(Partial) Operational Readiness Clearance (Non-beam operation)

DECAM

AUTHORIZATION TO PROCEED WITH THE UNATTENDED OPERATION OF CTIO LN2
CRYOCHILLER SYSTEM OF DECAM IN SIDET

Figure 2. New replacement water tight enclosure. All penetrations are in the bottom of the enclosure.

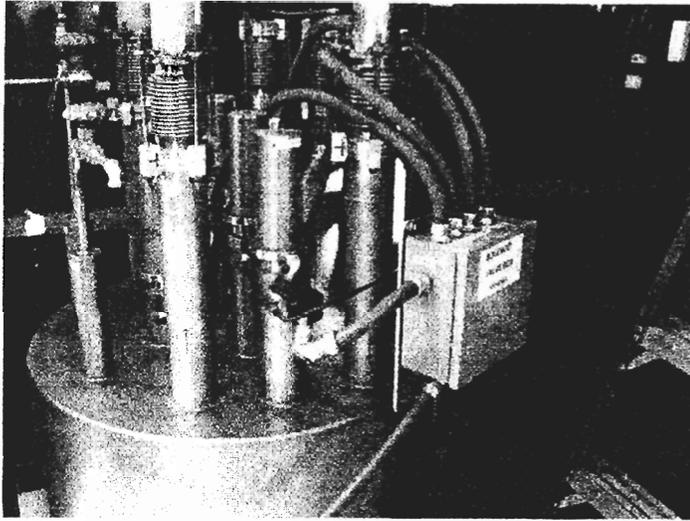
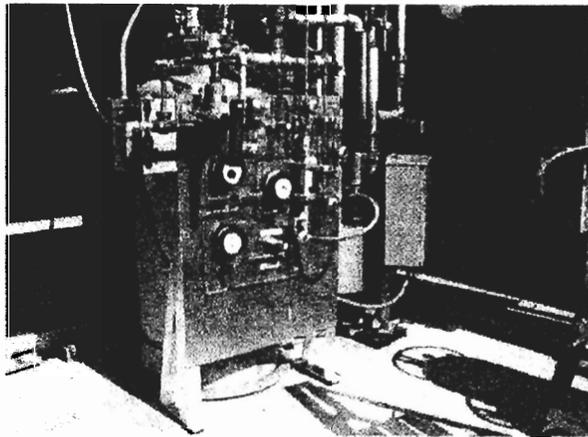
3. The Solenoid Valve Box Wiring Enclosure needs to be repaired or replaced. The enclosure is rated for use in damp or wet locations but, investigation showed the enclosure was allowing water to enter. The cause might be associated with the use of the wrong type of fitting, to large of a knockout used or hole cut when installing the fitting, or a poor seal on the cover door.

- 1) AC solenoid small outdoors enclosure not water tight.

The enclosure has been replaced. The enclosure is larger and is now watertight. All penetrations are in the bottom of the enclosure. All solenoids were moved from the external valves to inside the water tight enclosure. All wire sizes, fuses, and the wiring diagram remains the same. See Figures 1 and 2 below.

Figure 1. Separate enclosure for 208 – 3 phase power shown in upper left corner of

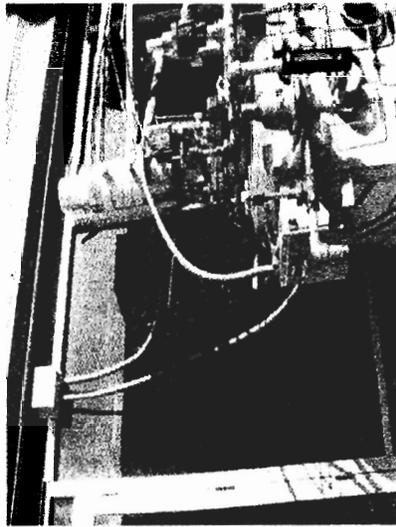
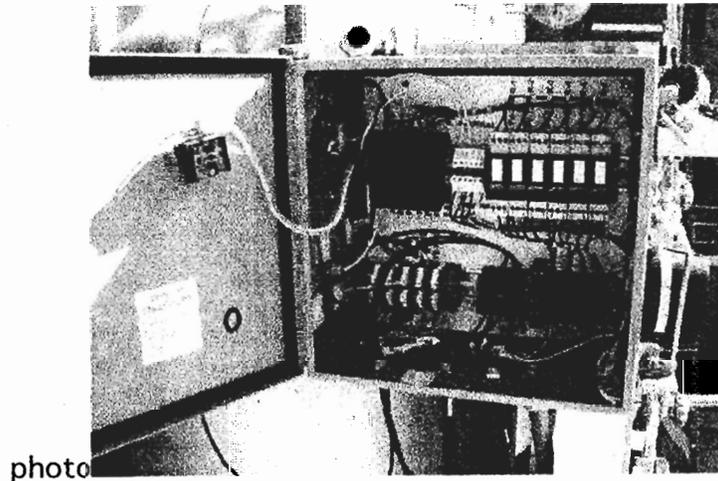
1. The DeCam Control Wiring Enclosure located outdoors contains both Class 1 control wiring and Class 2 power distribution wiring (220 VAC motor power). This is prohibited by the 2008 NEC Code Article 725.48(B) (1). The article states:

1) Mixed power in the outdoors large electrical enclosure.

The 3 phase 208 VAC is separated out of the enclosure. The separation occurs in a different enclosure located above the LN2 dewar. See photos below.

Figure 2: Shows all 3 phase power removed from the lower enclosure.

Seal tight fittings are water tight, and contain seals.

Figure 3. Small outdoors enclosure, Powered only during attended hours.

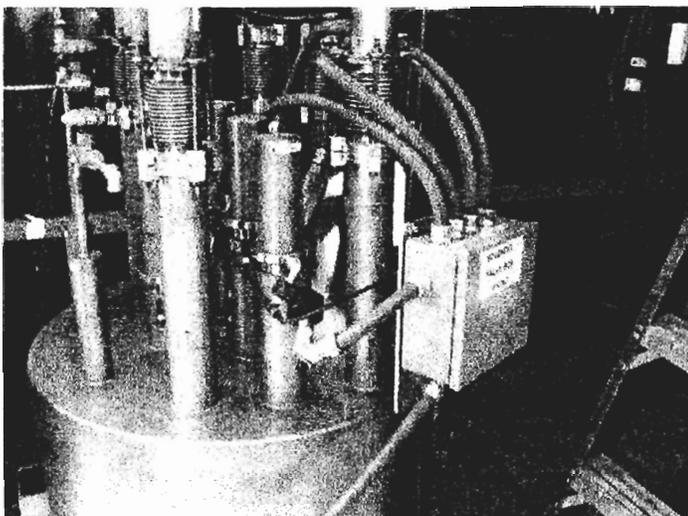
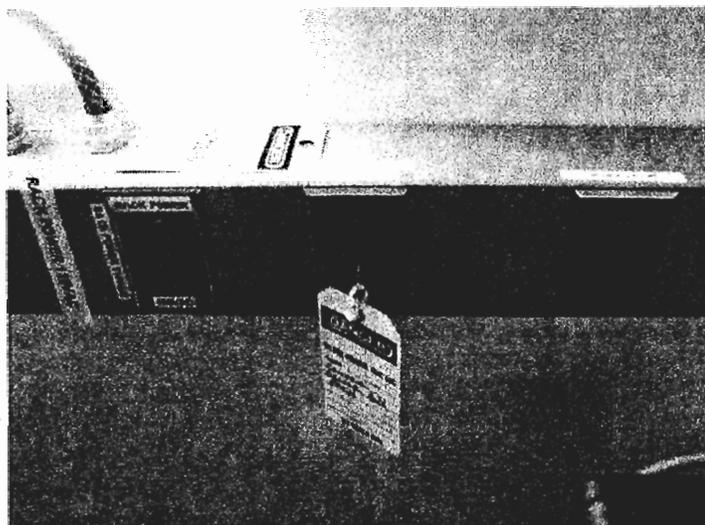
2) AC solenoid small outdoors enclosure not water tight.

The enclosure needs to be replaced. In the short term we will not power this enclosure in an unattended mode. Administrative control of the power to the enclosure is controlled with a switch indoors near the process PC. Herman Cease will take administrative control over the switch to ensure that the enclosure is not powered in off hours. Once the enclosure is replaced, we will ask for a new review of the system.

Figure 4. Key switch for AC power to the small outdoors enclosure.

Key is under administrative control by Herman Cease.
